MONTGOMERY COUNTY HISTORIC PRESERVATION COMMISSION
STAFF REPORT

Address:	2115 Salisbury Road, Silver Spring	Meeting Date:	5/8/2024
Resource:	Outstanding Resource (Linden Historic District)	Report Date:	5/1/2024
Applicant:	Brett Howard	Public Notice:	4/24/2024
Review:	HAWP	Staff:	Dan Bruechert
Case Number:	1066554	Tax Credit:	N/A
PROPOSAL:	Hardscaping, landscape alteration, gazebo removal, and tree removal

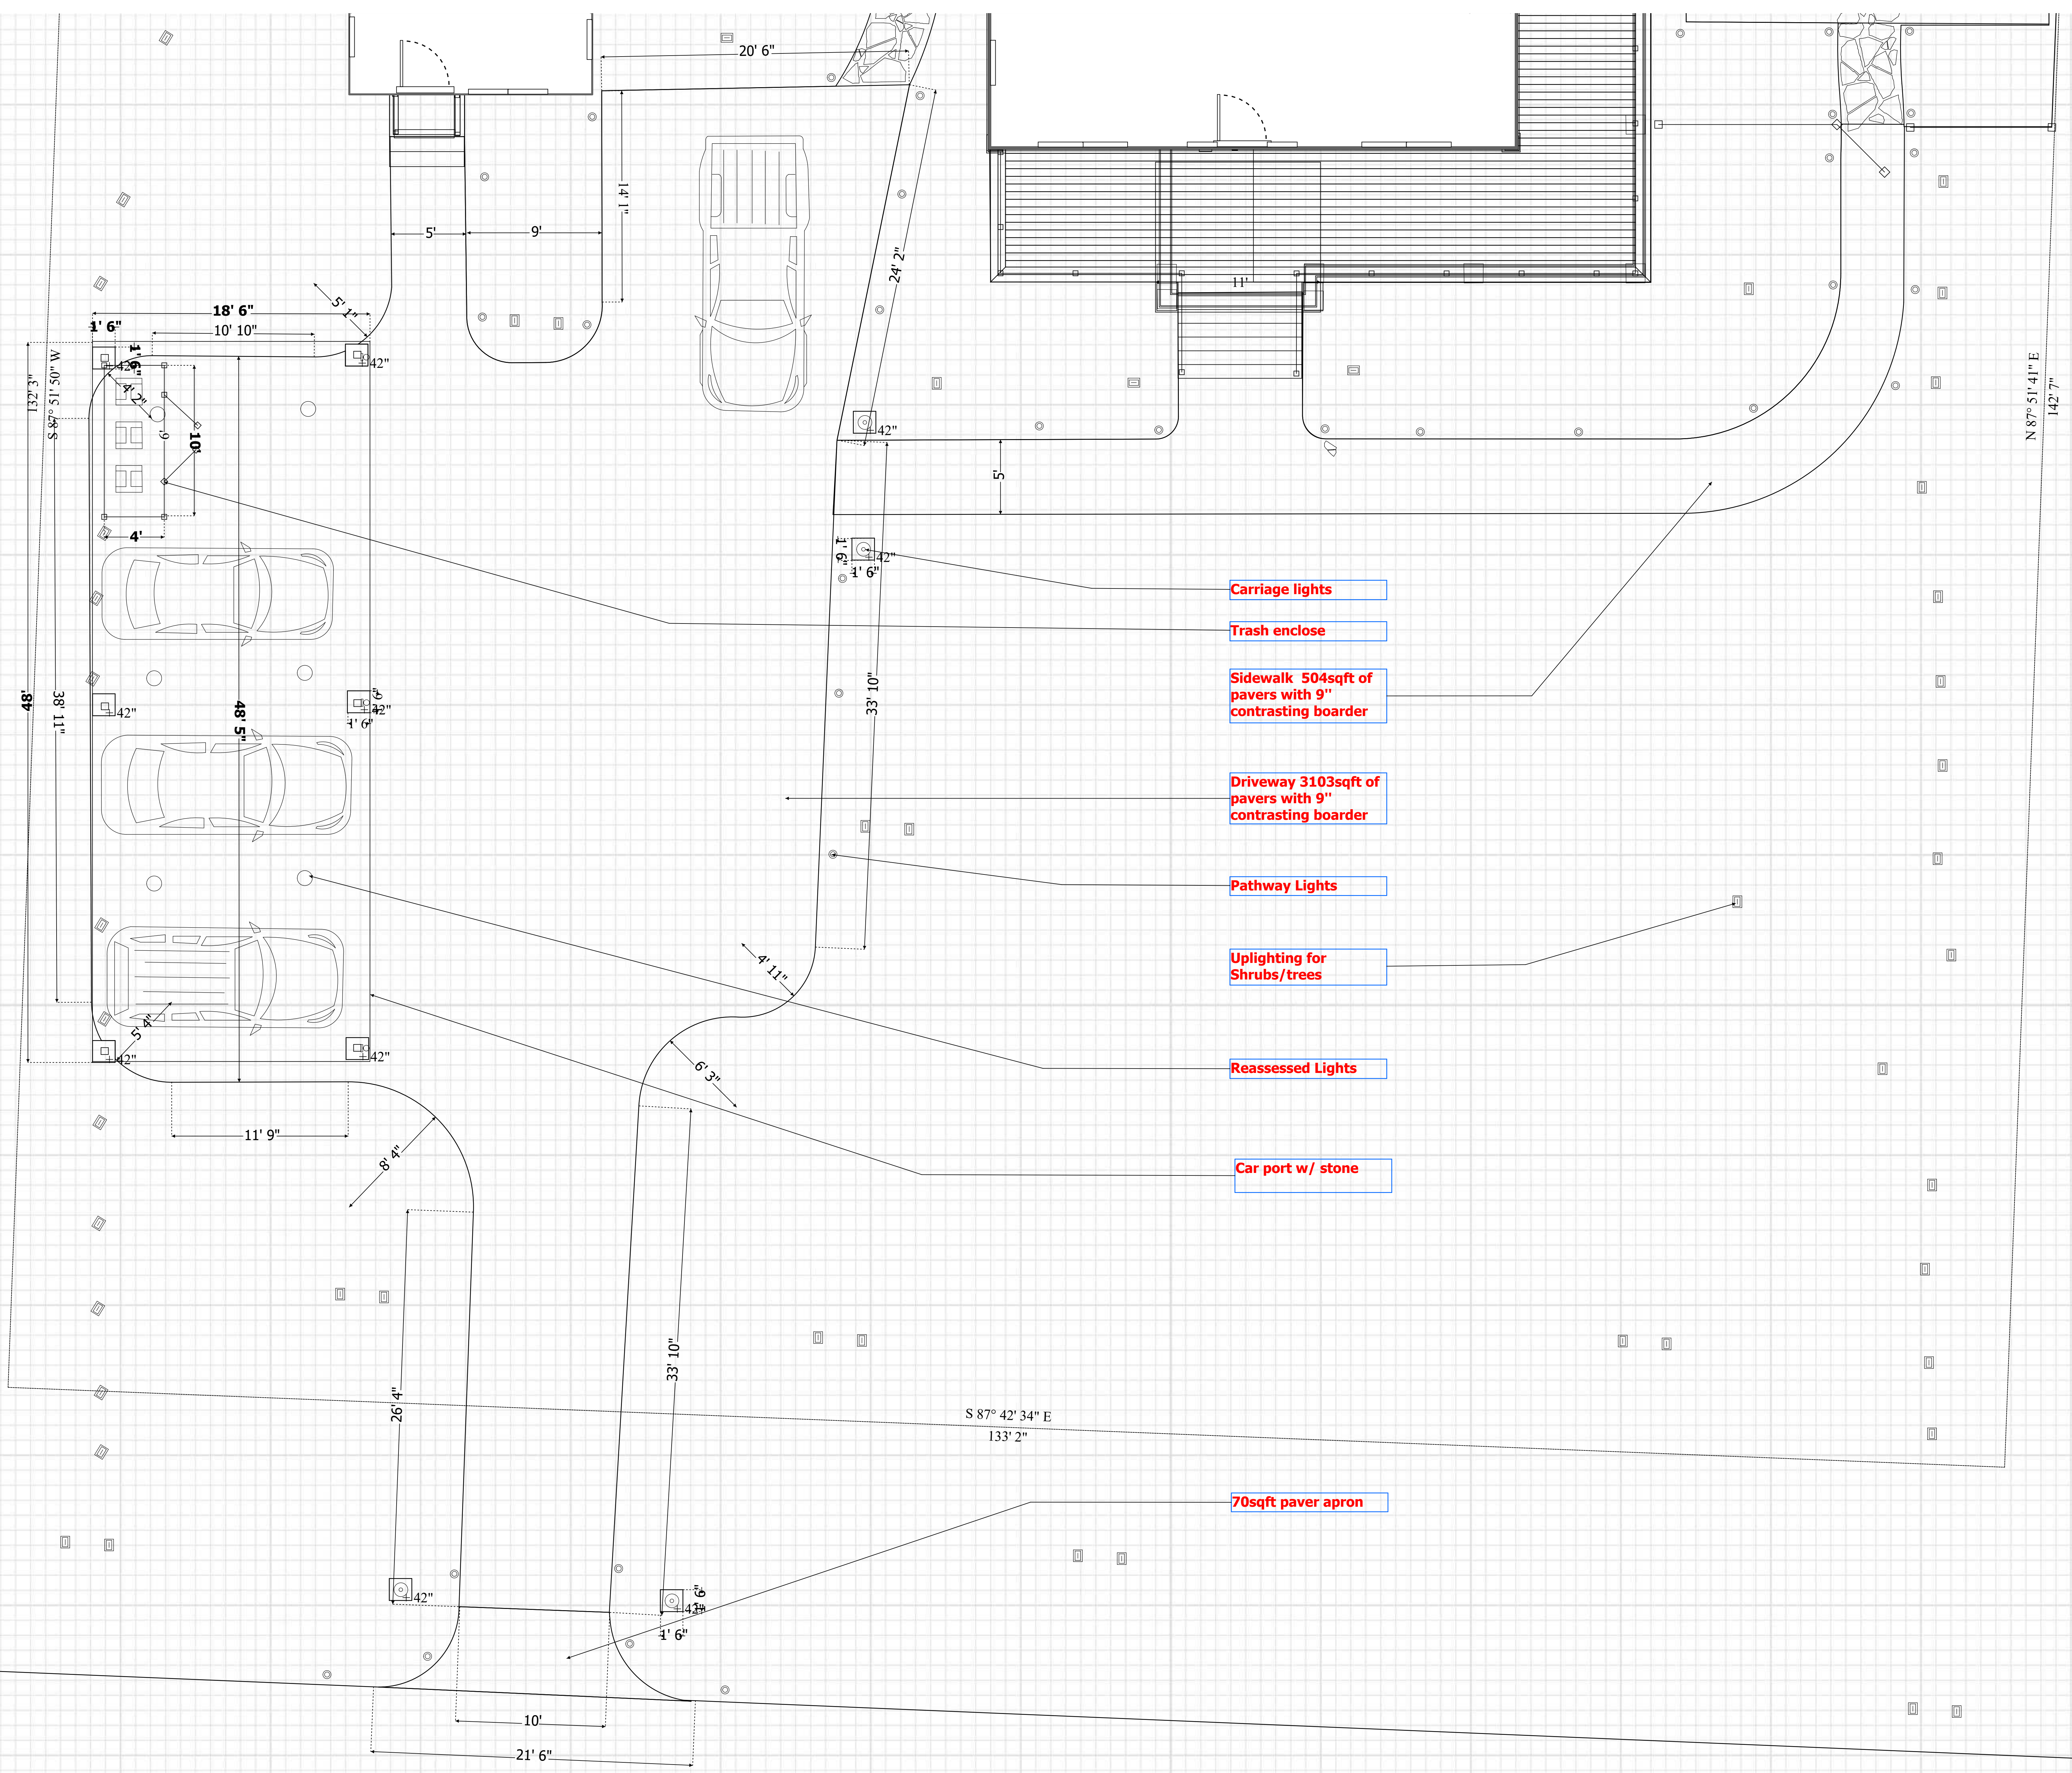
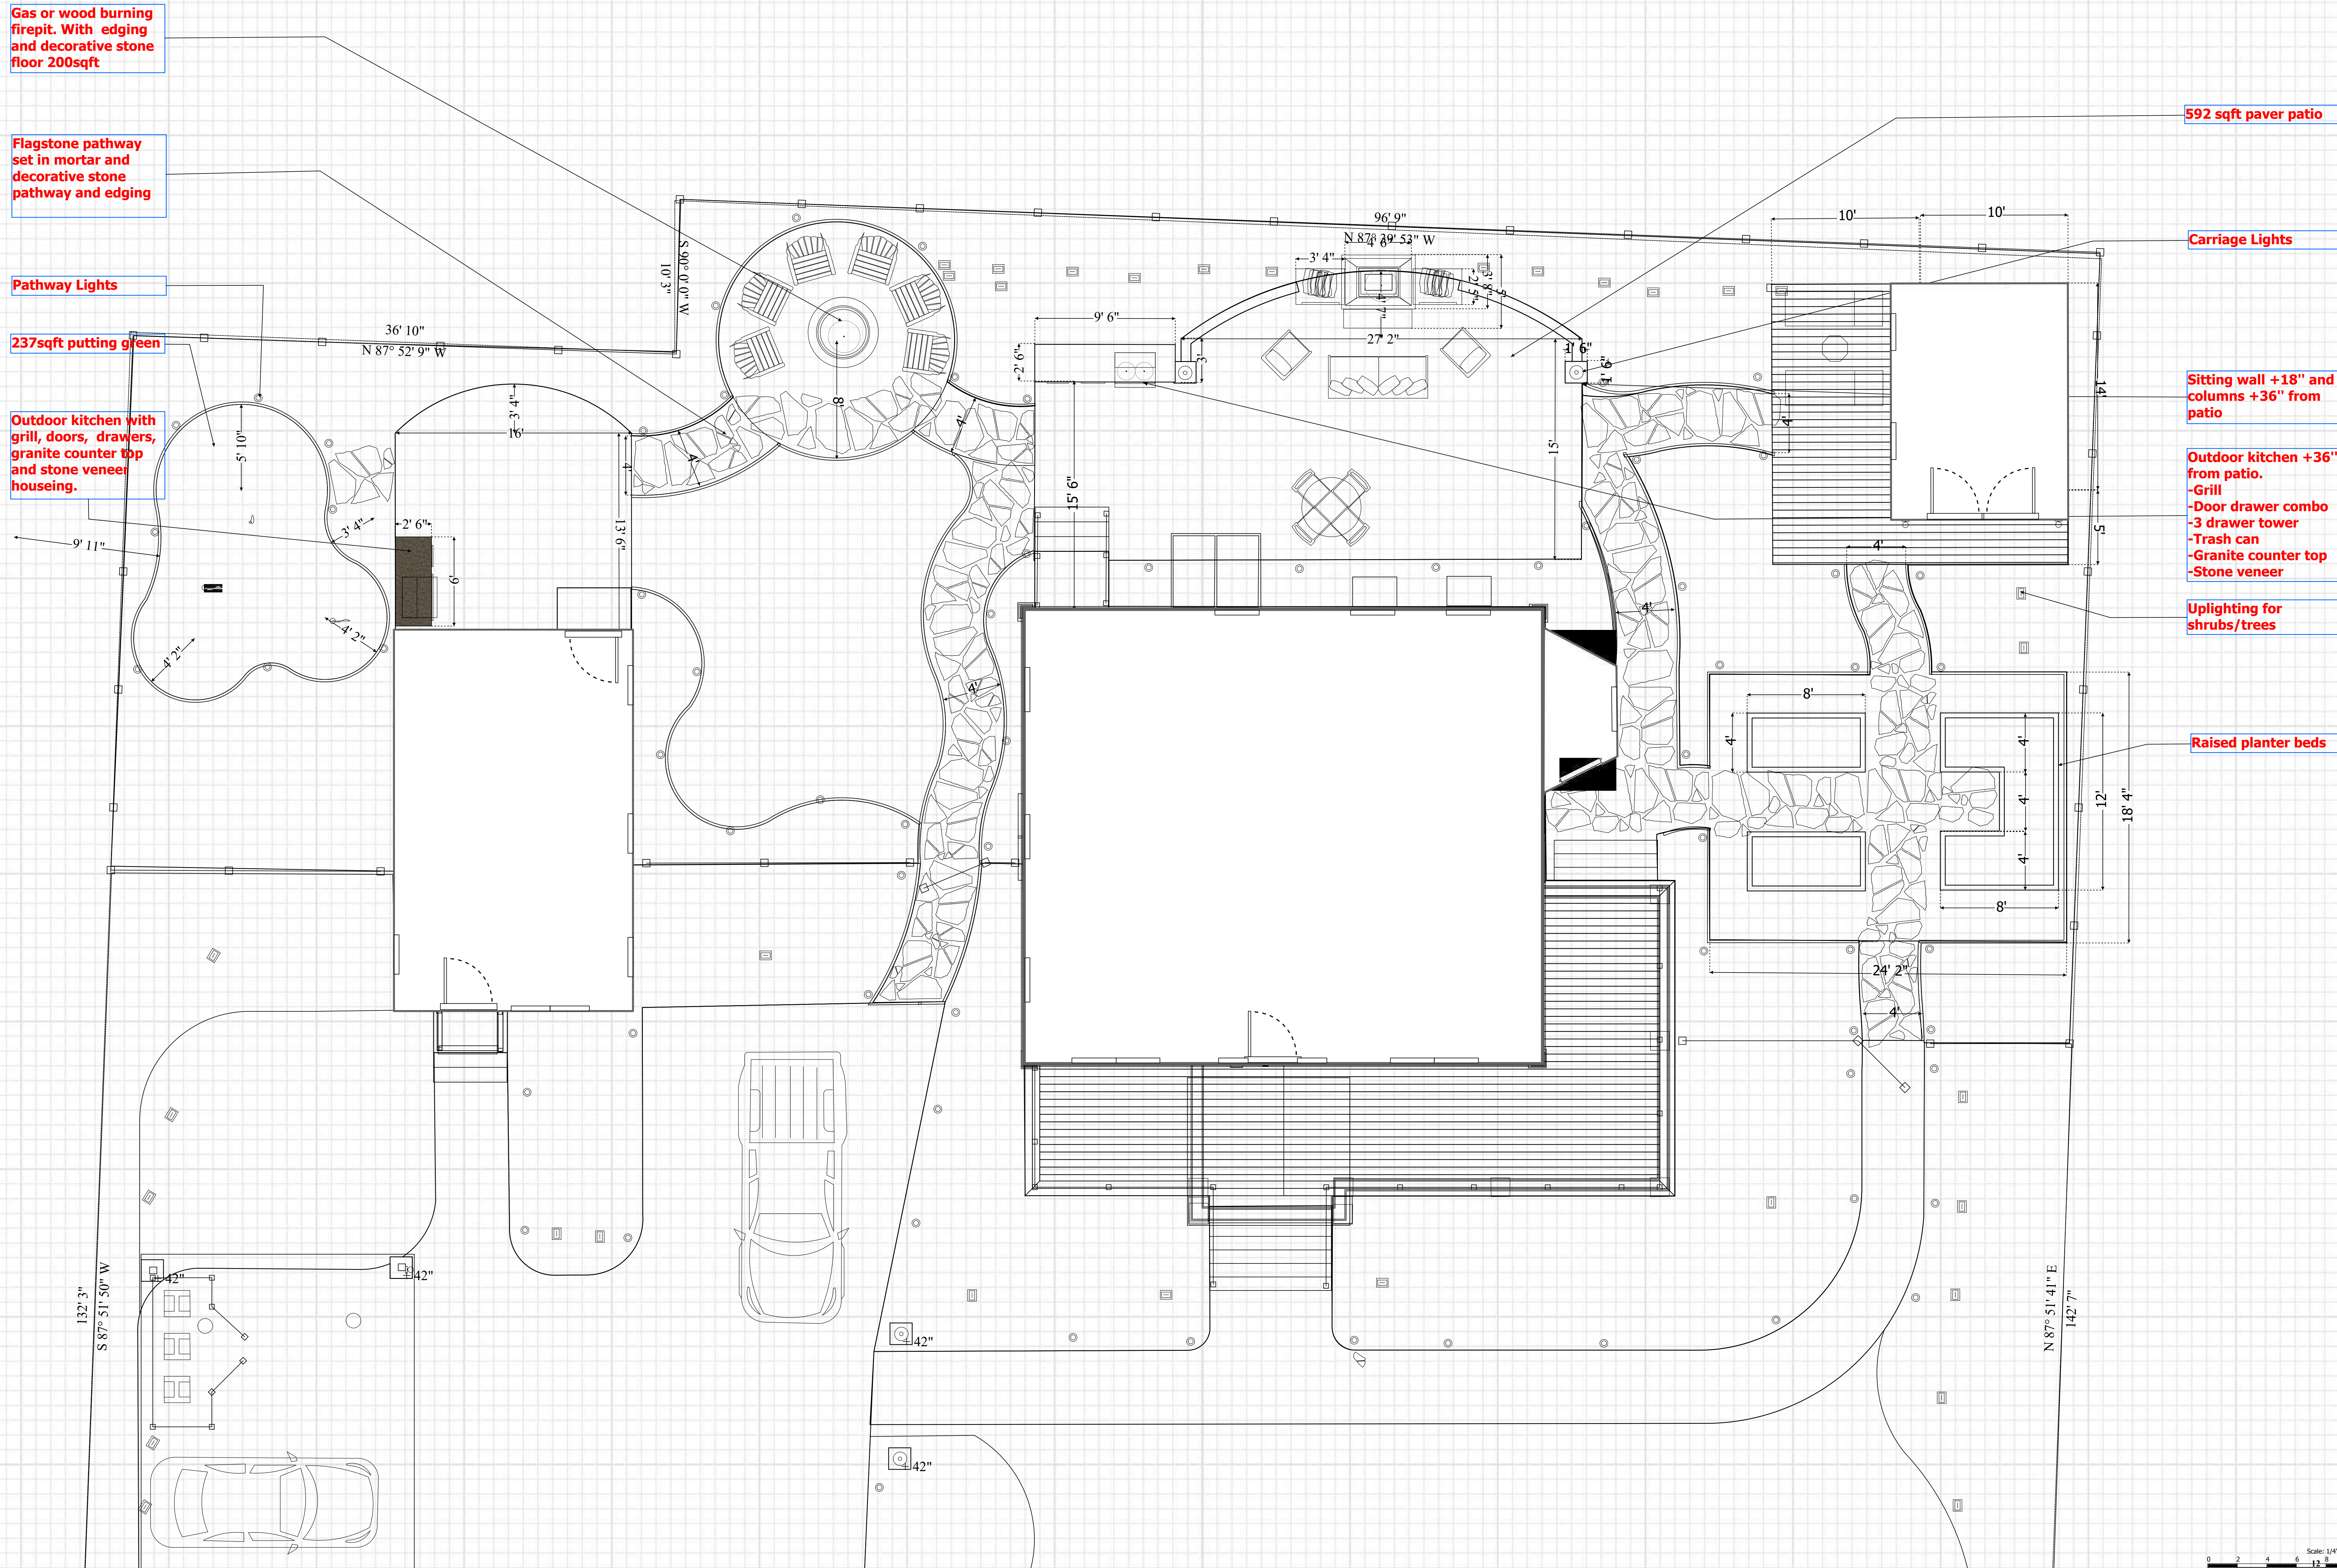
The applicant proposes to remove the existing driveway and construct a new driveway using permeable pavers with a 9" contrasting border; the existing concrete apron will also be removed and replaced with pavers. The front concrete walkway will also be removed and replaced with pavers matching the driveway and will be expanded to wrap around the east side of the house. At the rear, the applicant proposes to construct a large patio, measuring approximately 19' × 36' (nineteen feet deep by thirty-six feet wide). The description of the work in the application identifies two potential manufacturers and colors of pavers but does not include the product line. A patio measuring 13' 6" × 16' (thirteen feet, six inches deep, by sixteen feet wide) will be installed directly behind the approved ADU. Finally, the applicant proposes to construct several new paths that will connect several of the outdoor elements. The paths are to be constructed using flagstones set in mortar with a decorative edging. All of the paths are located at the rear of the house.

Staff finds the existing landscaping at the rear of the property does not contribute to the historic character of the site or the surrounding district. While Staff generally prefers to see gravel driveways retained, Staff finds the proposed paver driveway will retain some of the existing driveway's texture, while improving drainage on the site. Staff additionally finds the proposed edged gravel is compatible with the formality of house design. Staff cannot provide any analysis for the proposed material, because the applicant did not provide a specification. However, Staff finds that a rustic paver is appropriate at the subject property and recommends the HPC include a condition for approval to this HAWP that delegates final review and approval authority to Staff and requires this information before final permit documents can be released. Staff recommends the HPC approve the new driveway under 24A-8(b)(2) and Standards 2, 9, and 10.

Staff further recommends the HPC approve the proposed paths. The paths are in locations that will not be visible from the right-of-way and Staff finds the proposed flagstones are compatible with the character of the site and surrounding district. Staff recommends the HPC approve the proposed paths under 24A-8(b)(2) and Standard 2.

The description of work in the application includes removing two trees, a ginko and a holly tree, to accommodate the proposed driveway. The description of the trees is 'medium-sized' and a diameter breast height (d.b.h.) measurement was not provided. The submitted site plan identifies one ginko tree immediately to the west of the driveway, but Staff was unable to find a holly.

Staff generally finds the character of the lot will not be significantly impacted by the loss of two trees, however, the information submitted does not provide enough information for Staff to come to a reasoned recommendation and instead recommends the approval of this HAWP not extend to the tree removal and require the applicant to return for an amendment to this HAWP. If the trees are smaller than 6" d.b.h. (six inches in diameter at breast height), then a HAWP is not required.

1. A material specification for the pavers for the driveway and front walk must be provided to Staff for review and approval. Final approval authority is delegated to Staff.
2. The approval of this HAWP does not extend to the removal of any trees larger than 6” d.b.h. (six inches in diameter a breast height). Any tree removal must be submitted to the HPC as an amendment to this HAWP or under a new permit number.
